ADDENDUM No1 Released Feb 22, 2018

1.2 FOR INFORMATION – Concerto Condition Survey Input Sample Template

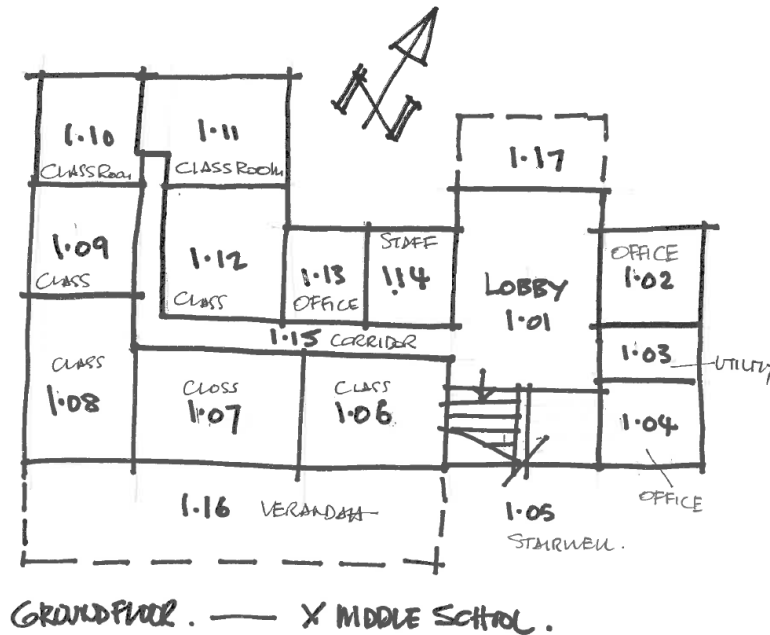
Attached as Appendix 1 to this addendum is a copy the Concerto Elemental Condition Survey Template in Excel Format. Refer to question 1 below. This input will be covered in the training sessions to be provided to the successful bidders.
